Subject: Stage 1 Road Safety Audit

Document title: Deal Farm, Bressingham

Subtitle: Stage 1 Road Safety Audit

Project name: Deal Farm - Stage 1 Road Safety Audit

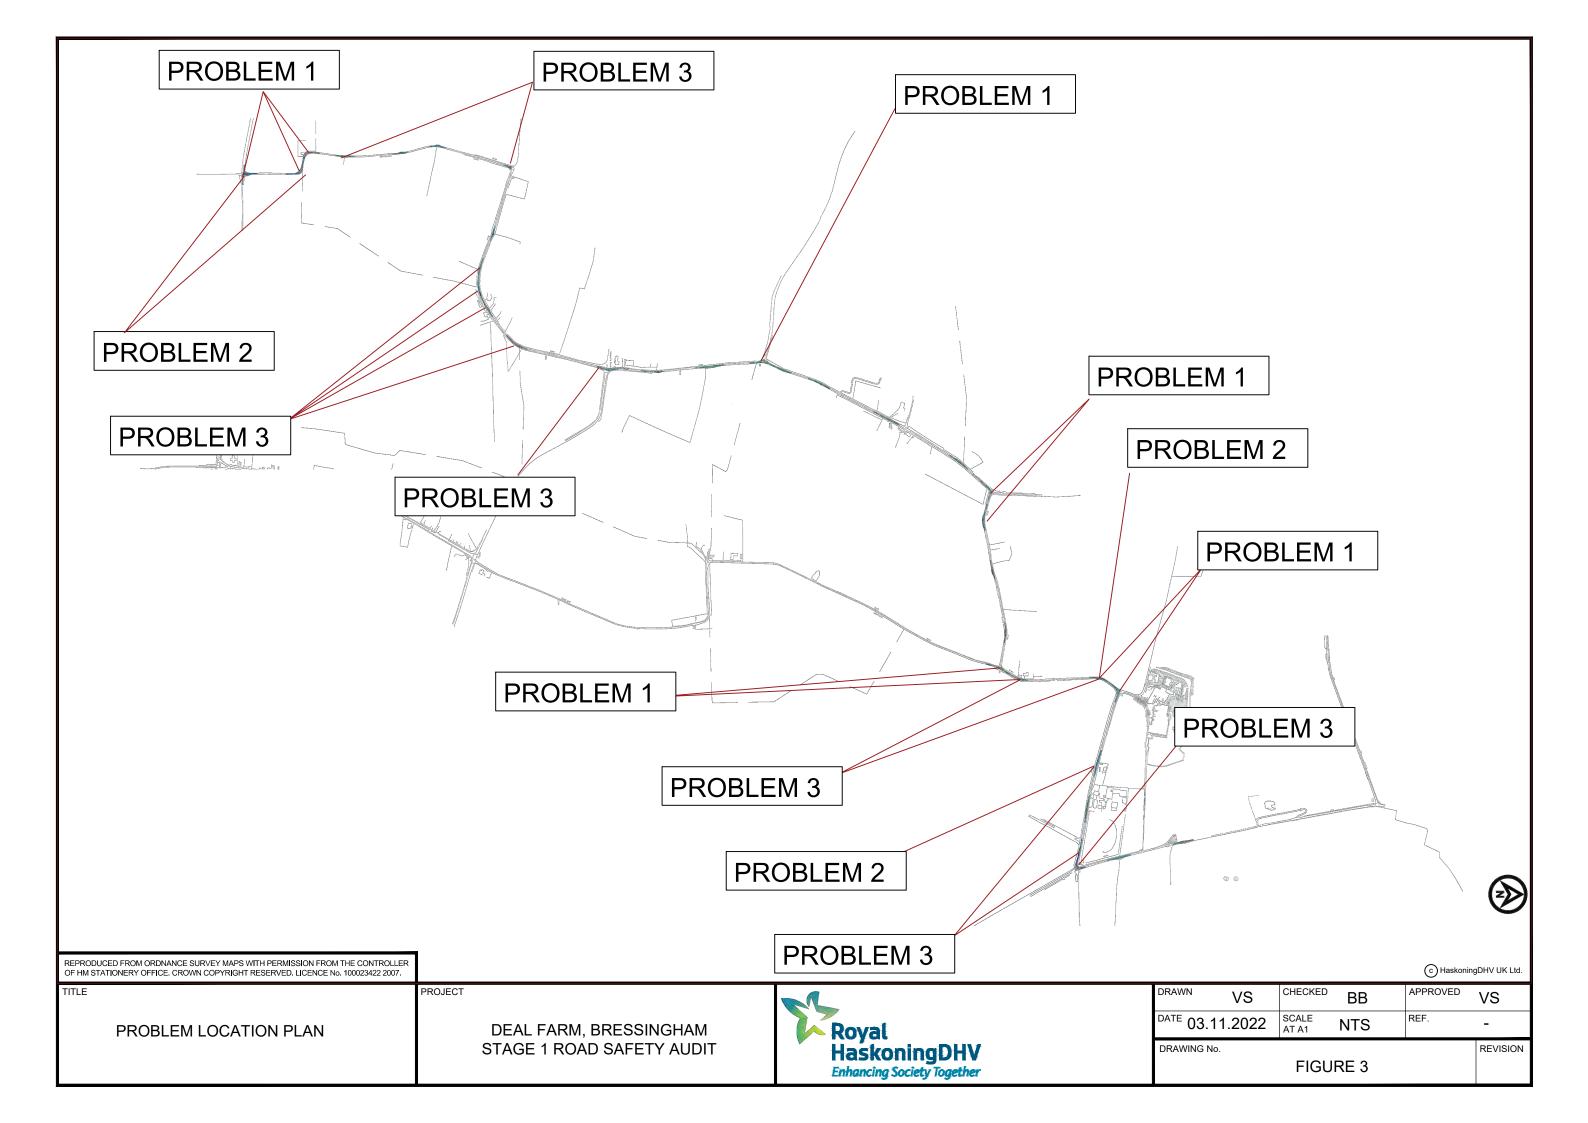
The completed highway works would provide 37 passing places on approximately 4.5 kilometres (km) of existing rural roads. The locations of the passing places have been numbered for ease of identification within this Stage 1 Road Safety Audit. The passing places and identification numbers are shown on **Figure 2** of this report. The locations of any problems identified by the Audit Team are shown on **Figure 3** of this report.

#### A1.1.1 Problem 1

**Location:** Proposed haul route; multiple locations as follows:

- Halford Lane (Location 1, Location 2, Location 3).
- Fersfield Road (Location 17).
- Nordle Corner (Location 22, Location 23, Location 25, Location 28, Location 29).
- Kenninghall Road (Location 30, Location 31).

**Summary:** Insufficient forward visibility in advance or and within the vicinity of the proposed passing places could result in sudden braking leading to the potential for rear end shunts or loss of control collisions.

**Description:** Landscaping, earth banks and the alignment of the existing carriageway currently restrict forward visibility between road users in the vicinity of 10 of the proposed passing places. Failure to provide and maintain adequate forward visibility could result in conflicts between oncoming vehicles or sudden braking leading to rear end shunts or loss of control collisions

It is recommended that drawings are prepared demonstrating that forward visibility requirements can be met and where any alterations to landscaping or the proposed geometry may be required. If it is not possible to provide adequate forward visibility, it may be necessary to relocate the passing place to a location where sufficient forward visibility can be achieved.

| Paragraph<br>No. in<br>Safety Audit<br>Report | Problem<br>Accepted<br>(yes/no) | Recommended<br>Measure<br>accepted<br>(yes/no) | Description / alternative measure  |
|---|---------------------------------|--|--|
| A1.1.1  | Yes                             | Yes  | Visibility check have been done and shown on the drawings. At detailed design stage, any vegetation/ obstruction to the visibility should be cleared; to be reviewed with the topographical survey and highway boundary.   |
